**COMMENTS OF GENERAL ELECTRIC COMPANY ON
PHASE 2 REPORT - REVIEW COPY
FURTHER SITE CHARACTERIZATION AND ANALYSIS
VOLUME 2B - PRELIMINARY MODEL CALIBRATION REPORT
HUDSON RIVER PCBs REASSESSMENT RI/FS
OCTOBER 1996**

November 21, 1996

Figure 1. Ratio of Post-Release to Pre-Release Fish PCB Concentrations for Pumpkinseed (PKSD), Brown Bullhead (BB), and Largemouth Bass (LMB) in Thompson Island Pool (TIP) and Stillwater Pool (SW)

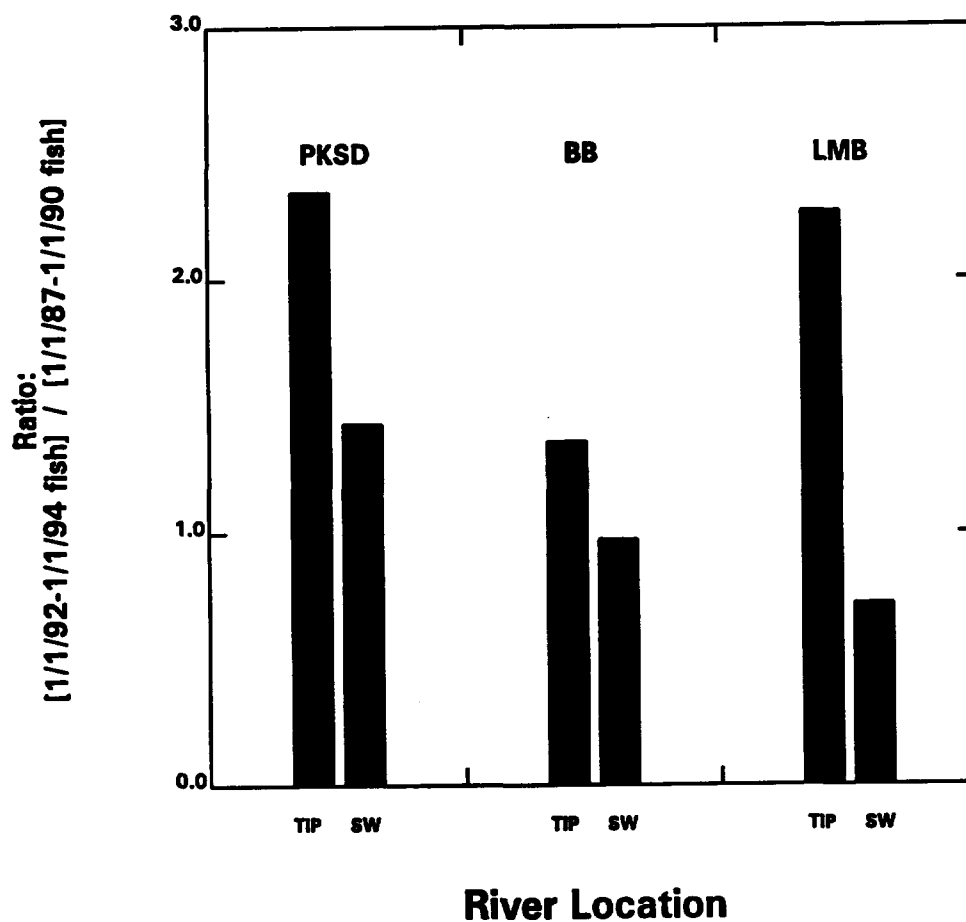
4. *There are markedly greater PCB concentrations in the surface sediments of the TIP (resulting from the 1991-1993 Allen Mill discharges) than reflected in the surface sediment data used in the model.* This hypothesis is plausible as it accounts for the coincidence in timing with the Allen Mill discharges. Two of the EPA high resolution cores collected from the TIP in 1992 (after the initial Allen Mill discharges) show an increase in PCB concentrations near the sediment-water interface. These surficial sediment layers reflect recent PCB deposits. As stated in Section II.B, comparison of PCB content in brown bullhead, largemouth bass, and pumpkinseed in the TIP and at Stillwater before and after the 1991-93 releases shows a greater increase in the TIP than at Stillwater (see Figure 1). The brown bullhead

and largemouth bass derive more of their diet from the sediment than does the pumpkinseed.

This suggests an increase in surface sediment concentrations of PCBs in the TIP following the discharges from the Allen Mill.

Figure 2. TIP Sediment PCB Profile (left) with Projected 1991 Profiles with Sedimentation and Dechlorination Mechanisms (center & right).

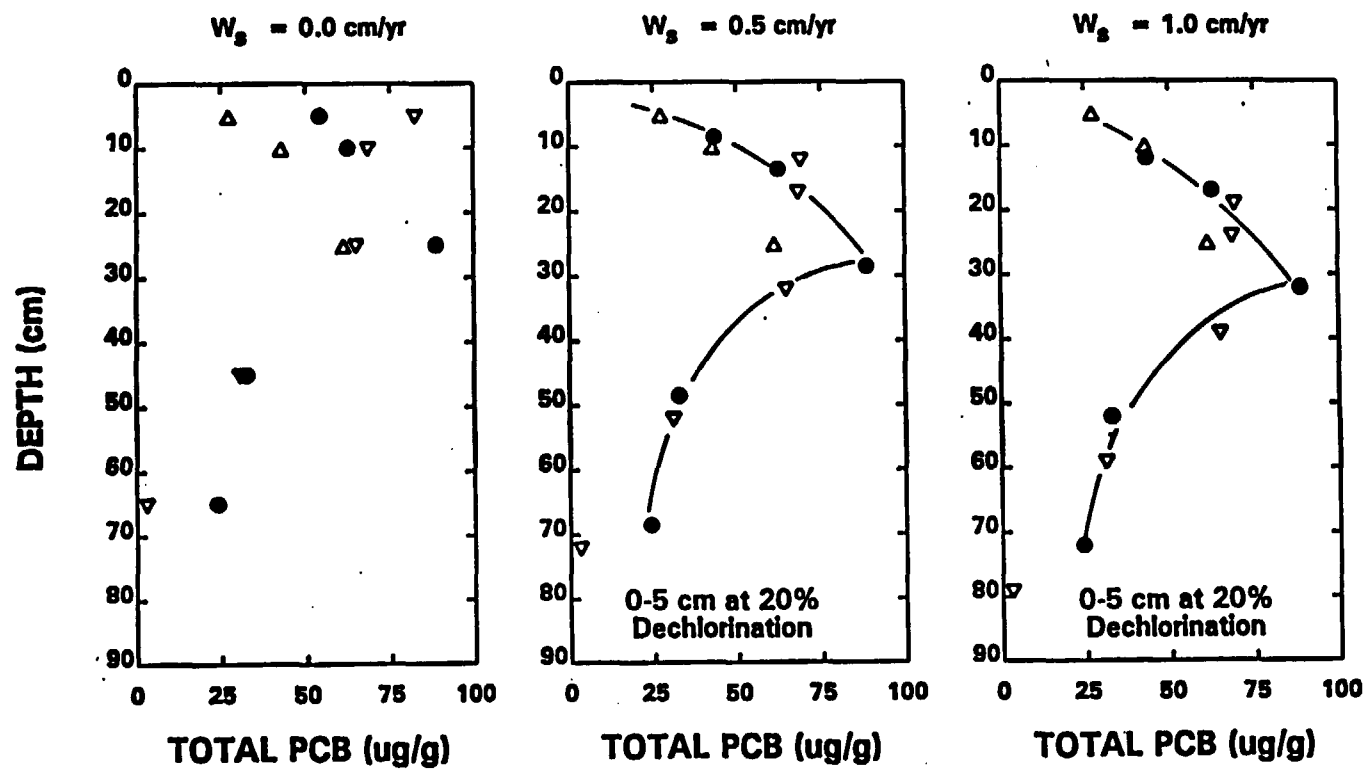
Long term burial as the dominant mechanism for loss of bioavailable PCBs is consistent with the available data reviewed to date. As an illustration, consider the vertical profiles of PCB concentrations in TIP sediment shown on Figure 2. Each panel shows measured

sediment PCB concentrations, averaged over selected depth intervals, for the years 1977, 1984 and 1991. In the panel on the left, the PCB concentrations for each depth interval are plotted against the depth of the slice. The surface to 5 cm slice is plotted at a depth of 5 cm, corresponding to the depth at which material would be buried below a mixed "active layer" 5 cm deep. The other concentrations are plotted at the depth below the sediment-water interface of the mid-point of the associated sediment core slice. When plotted in this manner, the only obvious pattern in the data is that the surface concentrations decreased from 1977 to 1984 to 1991, and the deeper concentrations (50 to 70 cm) are relatively higher than the surface sediment concentrations.

The middle and right panels of Figure 2 show these same sediment PCB profiles, but with the measured profiles modified in the following manner. First, the surficial (0-5 cm) concentrations are reduced by 20%, corresponding to an upper bound limit to the potential degradation of PCBs associated with anaerobic dechlorination processes. (This decrease is only applied to the mixed surface layer, since this is the only layer likely to have relatively recently deposited, undechlorinated PCBs). Second, the 1977 and the 1984 PCB profiles are shifted downward to correspond to the depth of burial that would occur from the time of sampling (1977 or 1984) to 1991. This vertical translation corresponds to a long term average net sedimentation rate of 0.5 cm/year on the middle panel and 1.0 cm/year on the right hand panel. With these modifications applied to the data, the blurred image described by the untranslated profiles on the left panel comes into focus and a relatively distinct, unified profile emerges. This is consistent with the conclusion that burial has simply moved the PCB profiles measured in 1977 and 1984

down in the sediment, modified by some degree of dechlorination, possibly in combination with other loss processes, in the surface layer. The actual burial rate is difficult to discern with precision, but this analysis suggests that it is on the order of 0.5 to 1 cm/year. Since the PCB data are reach average results, this burial rate is indicative of a reach average long term net sedimentation rate. These data do not support EPA's hypothesis that PCBs are being "flushed" from the sediment at the high rate calculated by the EPA model.
